Project	CMHA Meadows RAD Renovations	Addendum Number	2
Project Number	18076.04	Date	09/12/2025
To	All Bidders		
<i>This addendum contains changes to the requirements of the bidding Documents, Project Manual and Construction Drawings which have been issued to date. Such changes are to be incorporated into the Construction Documents and shall apply to the work in the same meaning and force as if they had been included in the original documents. Wherever this Addendum modifies a portion of a paragraph of the Project Manual or a portion of any Drawing, the remainder of the paragraph or Drawing shall remain in force.</i>			
General	Clarifications: <i>Bid Form: See attached revised bid form showing line item for permit fee included.</i> <i>Do the gas lines in the laundry room need to be removed? Is the furnace the only gas fed item within the unit?</i> Response: Gas lines are stubbed into the laundry area for future use of a gas appliance. No work is to be done on the gas lines in the laundry room as a part of this renovation. <i>How should the curb be addressed where the sidewalk on the accessible route widens?</i> Response: See Civil drawings updates as a part of this Addendum. <i>Do y

FIRST FLOOR UNIT 3-B
HVAC PLAN
SCALE: 1/4"=1'-0"

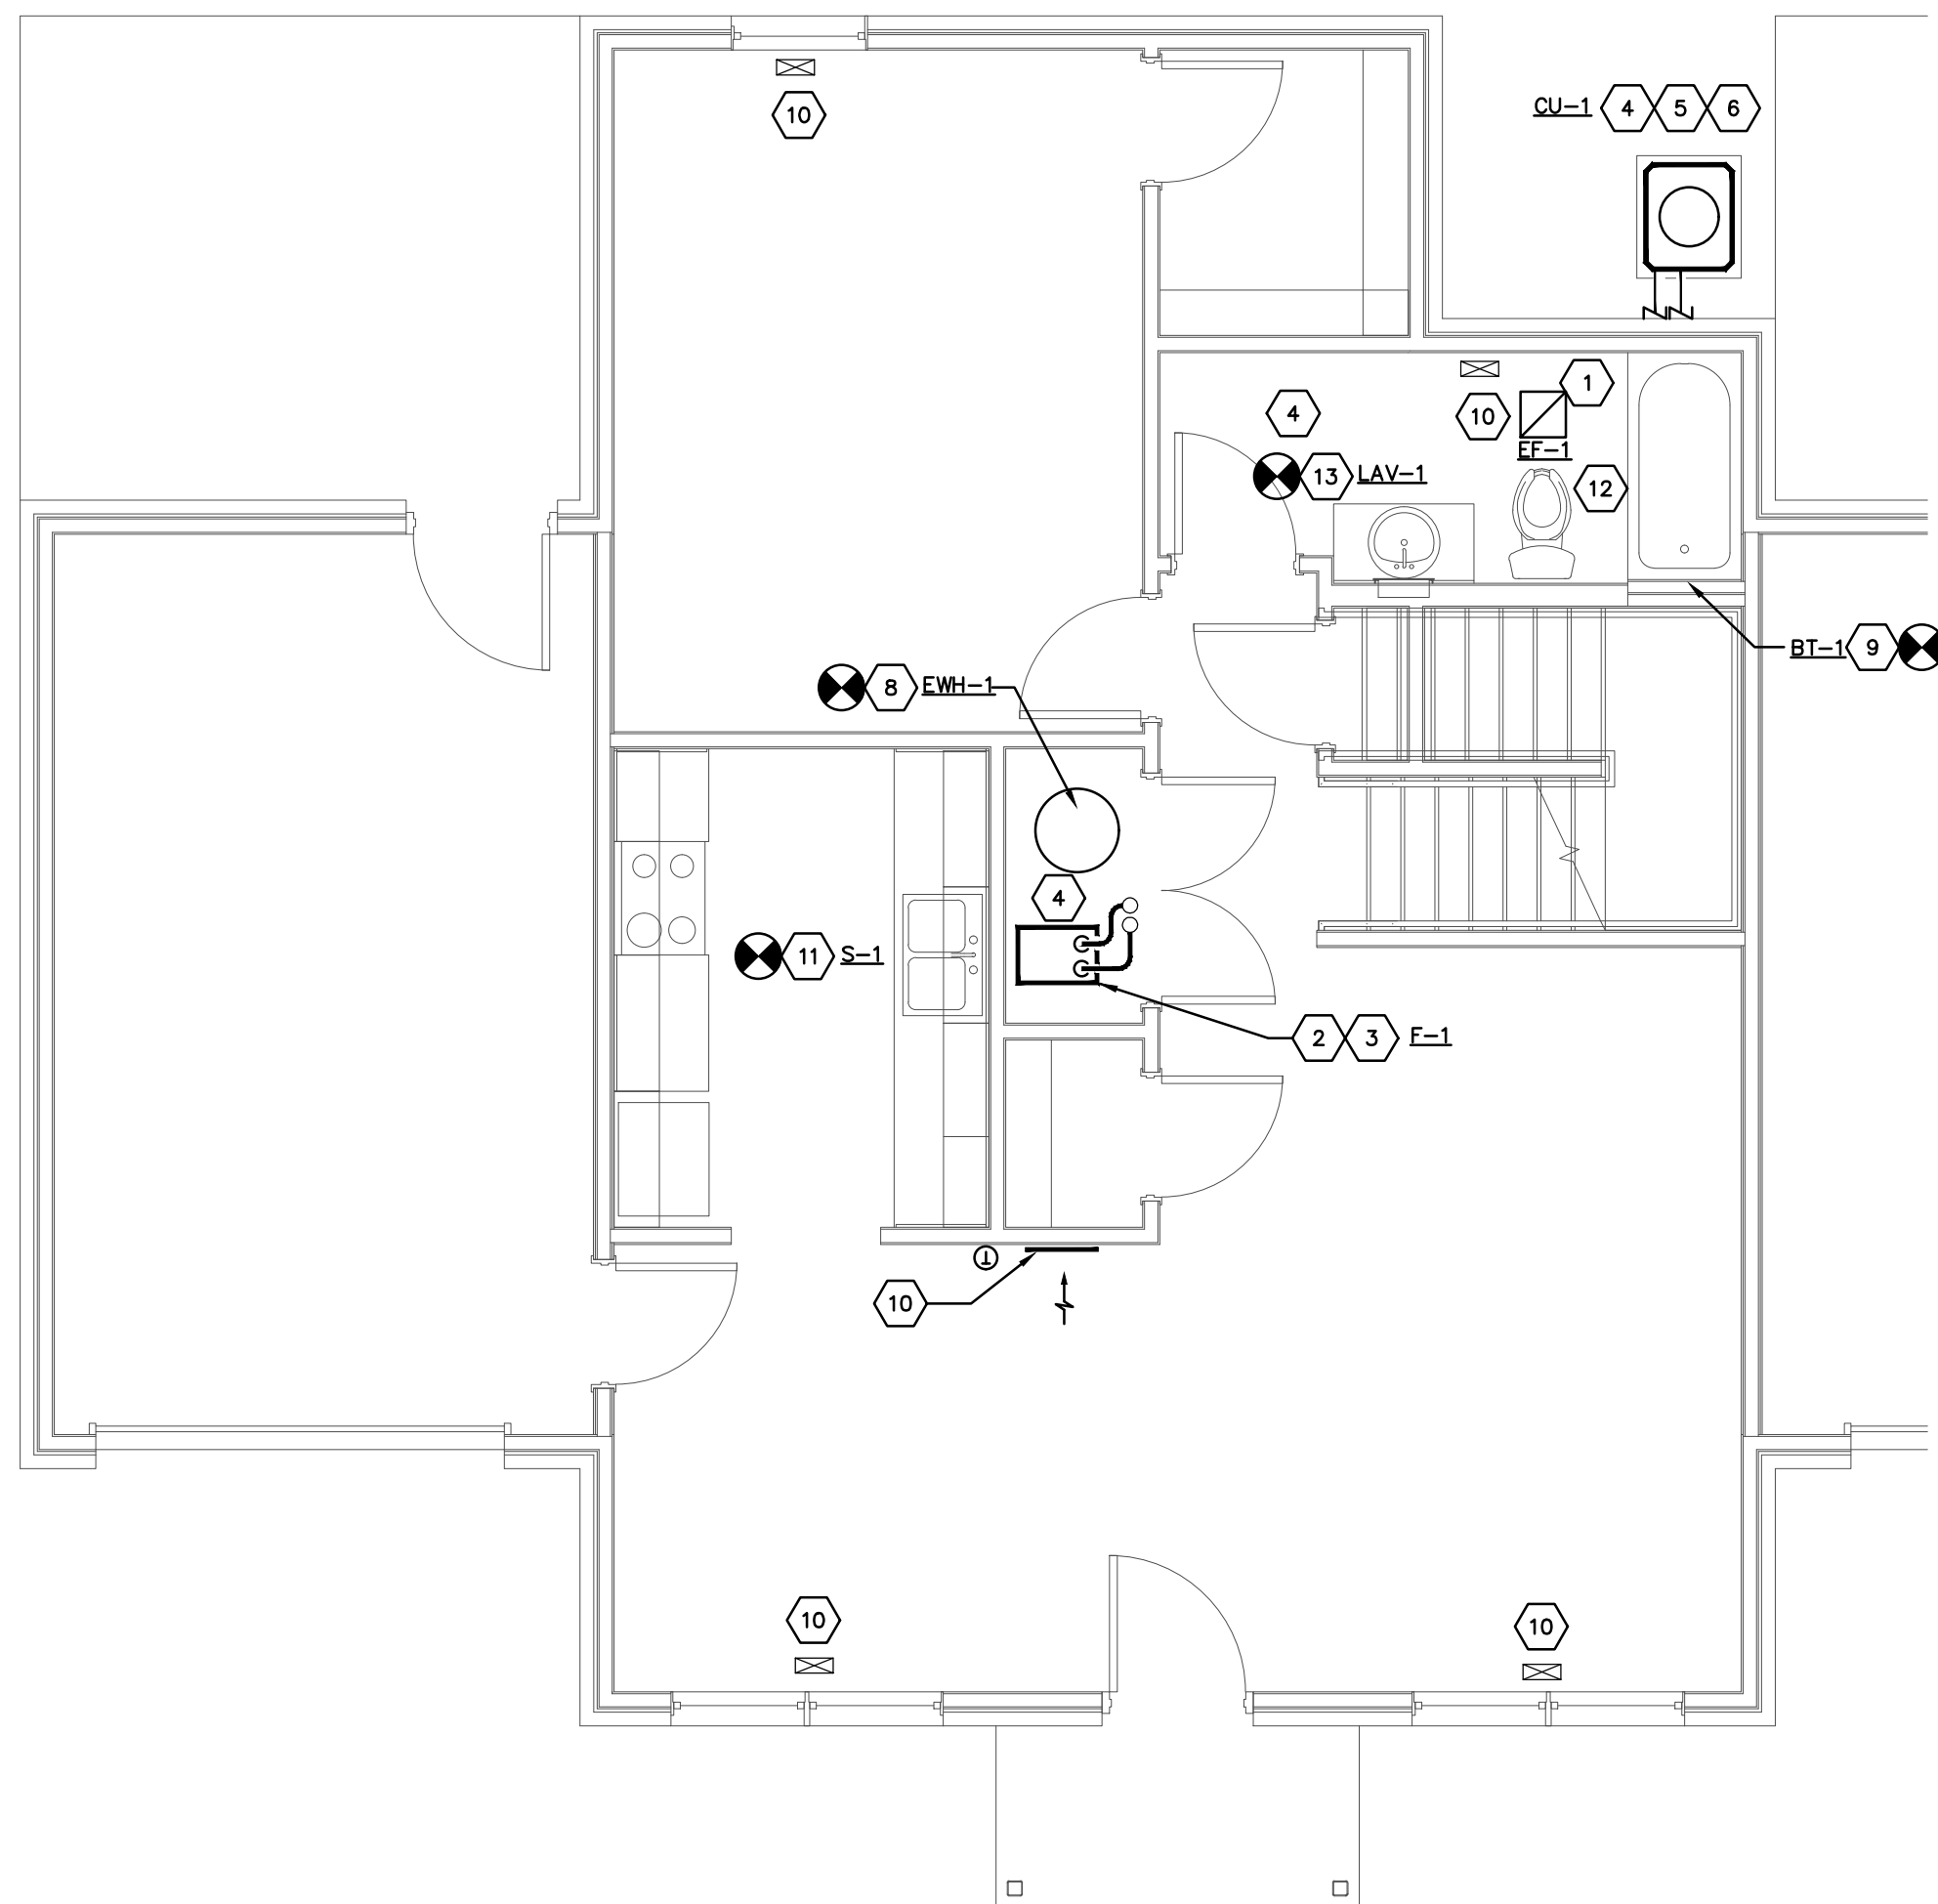
1. ADDED WB-1 washer box replacement in Unit 3-B second floor and Unit 4-A second floor.
2. ADDED Coded Note #14.

- REPLACE EXISTING WASHER BOX AT THIS LOCATION. FIELD VERIFY EXACT LOCATION. SEE "PLUMBING FIXTURE SCHEDULE" ON SHEET H900.

Sheet E100 – ELECTRICAL SITE PLAN

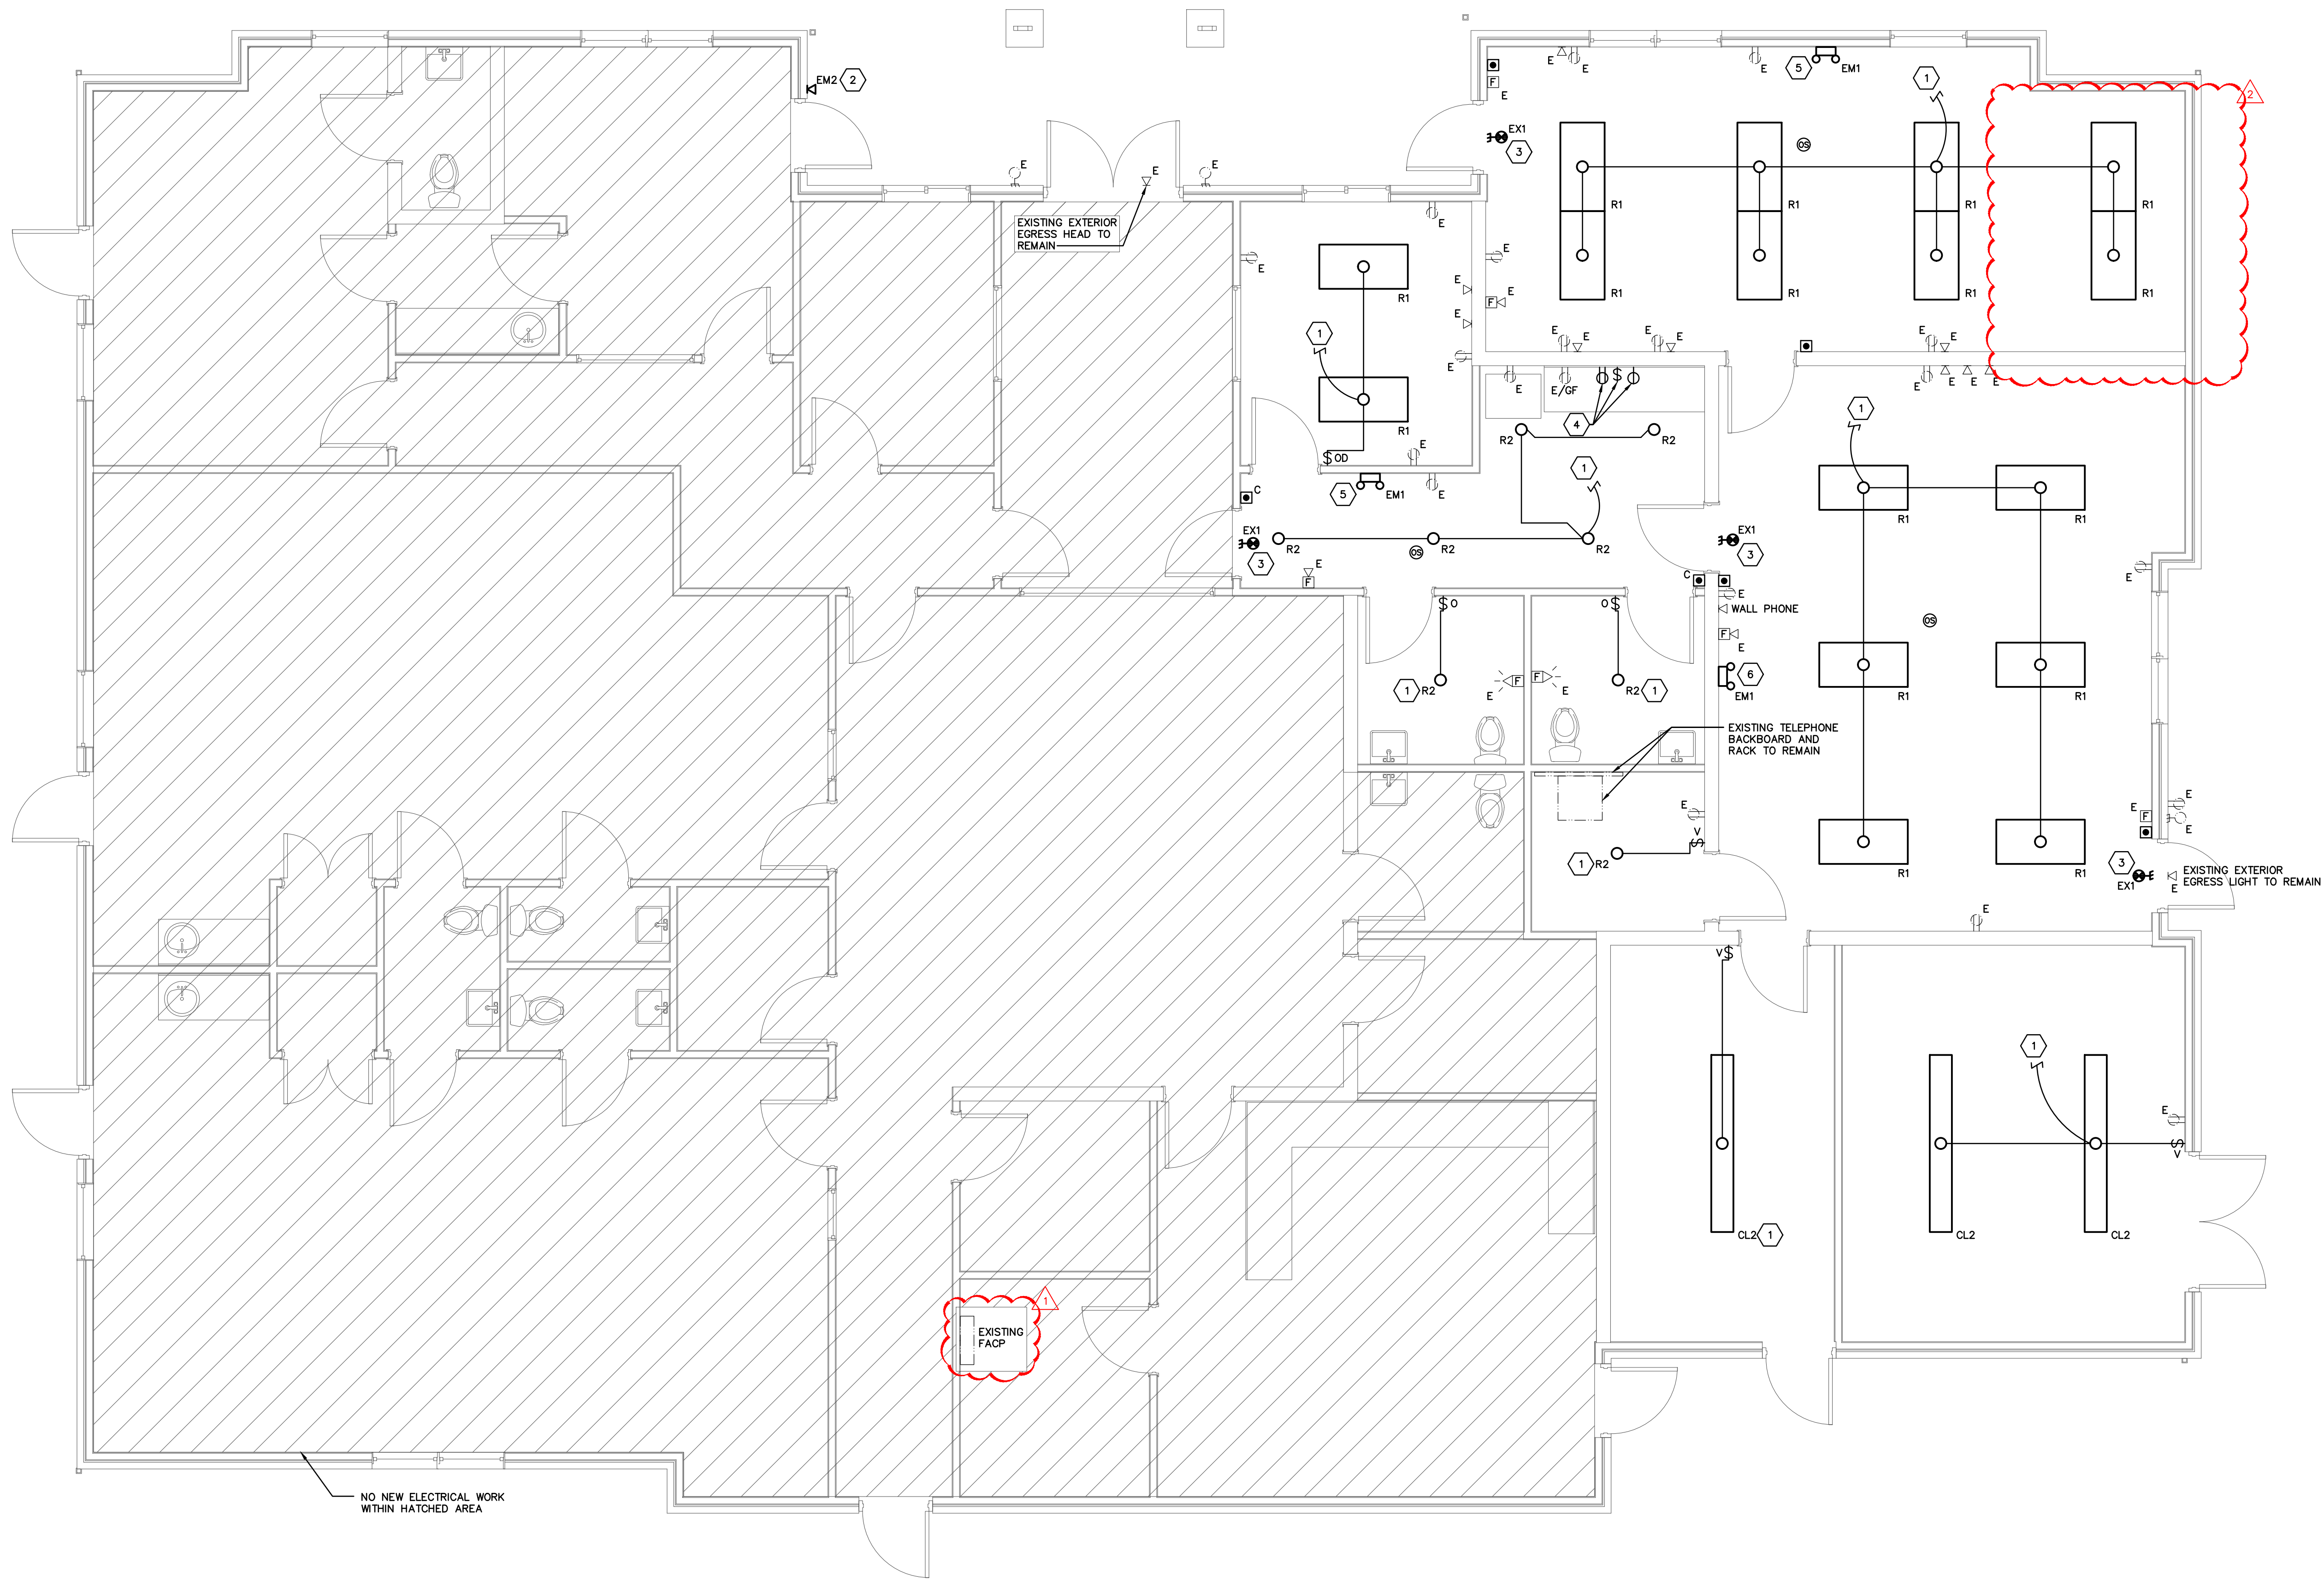
1. REVISED connections to heaters from hardwire to receptacle.
2. ADDED new conduit pathway for data connection to fire alarm control panel in community building.
3. ADDED duct bank detail.

- PROVIDE IN GROUND ELECTRICAL PULLBOX EQUAL TO HUBBELL QUAZITE PG SERIES. SIZE PER NEC 314. PULLBOX SHALL HAVE HEAVY DUTY COVER WITH STAMPED LOGO "POWER". COORDINATE PULLBOX LOCATION WITH CIVIL PRIOR TO POURING IN.
- PROVIDE 120V CONNECTION TO (2) TAMPER SWITCHES INSIDE BACKFLOW ENCLOSURE. COORDINATE CONNECTION LOCATION WITH WATER SERVICE PLAN. CONNECT TO EXISTING FIRE ALARM CONTROL PANEL IN COMMUNITY BUILDING, SEE SHEET E103 FOR LOCATION.
- PROVIDE GFI RECEPTACLE ON INTERIOR OF ENCLOSURE FOR HEATER.
